**Subject: Comments on the 550 Piercy Road Industrial Development Project (SCH No.
 2023060249)**

We have reviewed the June 2023 Initial Study and Mitigated Negative Declaration (“IS/MND”) for the 550 Piercy Road Industrial Development (“Project”) located in the City of San Jose (“City”). The Project proposes to construct 430,000-square-feet (“SF”) of industrial space and 427 parking spaces on the 28.9-acre site.

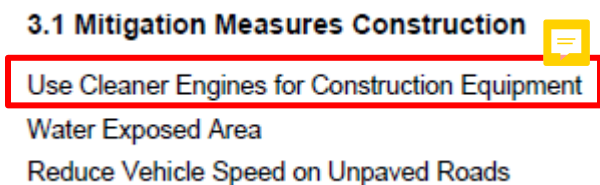
Review of the CalEEMod output files demonstrates that the “550 Piercy Rd” model includes the following construction-related mitigation measures (see excerpt below) (Appendix A, pp. 59).

As a result, the model assumes that the Project’s off-road construction equipment fleet would meet Tier 4 interim emissions standards (see excerpt below) (Appendix A, pp. 34).

However, the assumption that the Project’s off-road construction equipment fleet would meet Tier 4 interim emissions standards remains unsupported for two reasons.
